1968 Corvette: Service Bulletin: Cracking of the Plenum at the Right Hood Latch Plate

Bulletin No: 68-T-68

Date: Nov. 11, 1968

RIGHT HOOD LATCH REINFORCEMENT PLATE INSTALLATION
1968 CORVETTE

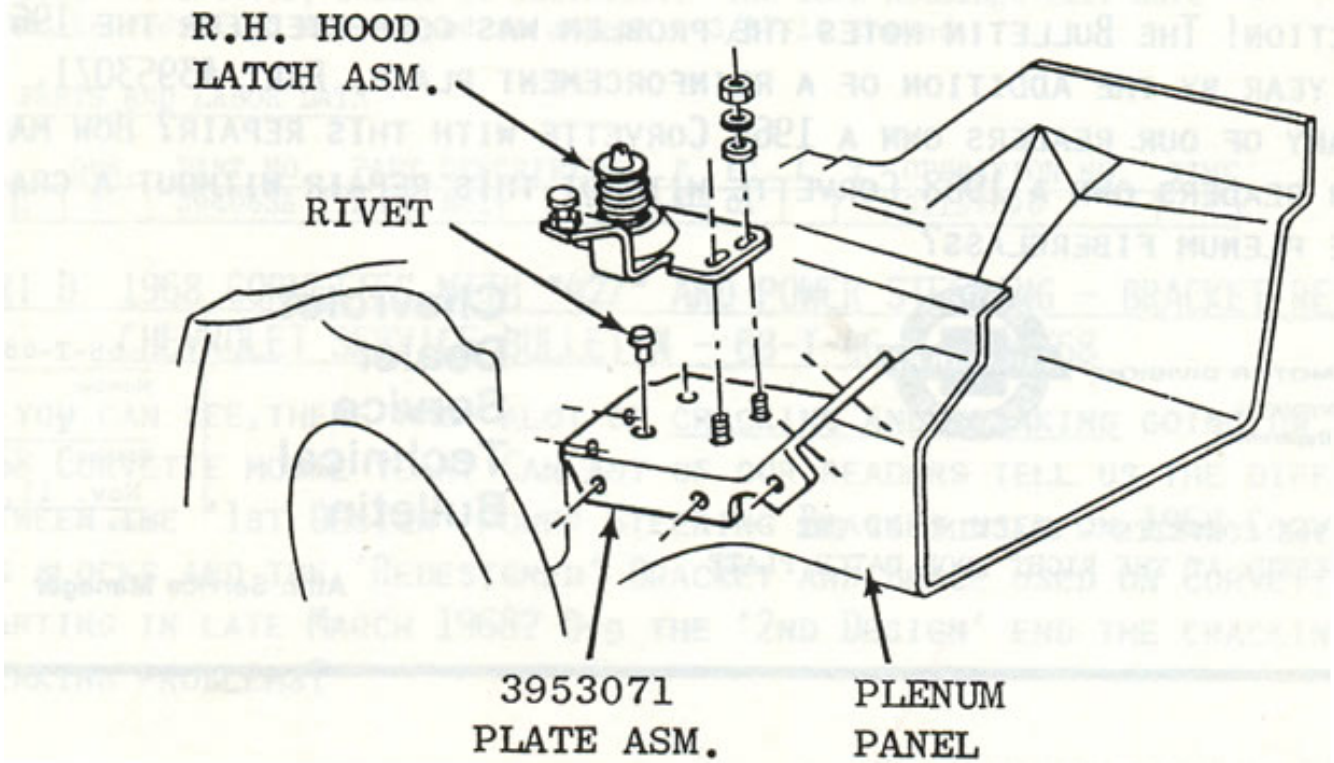
Cracking of the fiber glass plenum in the area of the right hood latch may be experienced on some 1968 Corvettes. This cracking is due to the manufacturing process of the plenum causing a glass rich condition in this area. This condition was corrected at the start of the 1969 production by the addition of a reinforcement plate to the area.

Whenever this cracking condition is encountered in the field, it may be corrected by riveting a reinforcement plate Part No. 3953071 to the outer surface of the plenum as outlined under Service Procedure.

1. Remove right hood latch assembly from the plenum panel and remove cowl vent grille.
2. Drill out two rivets retaining existing stud plate to plenum using a 7/32" dia. drill bit. Remove stud plate through cowl vent opening.
3. Position reinforcement plate on plenum as shown in sketch and drill seven (7) holes 7/32" dia. at hole locations in plate. The two (2) outboard holes are not accessible for drilling.
4. Attach the reinforcement plate to the plenum using 3/16" x 5/8" "Pop" Rivets.
5. Install and adjust right hood latch assembly as outlined in the August 1968 issue of "Chevrolet Service News." Install cowl vent grille.
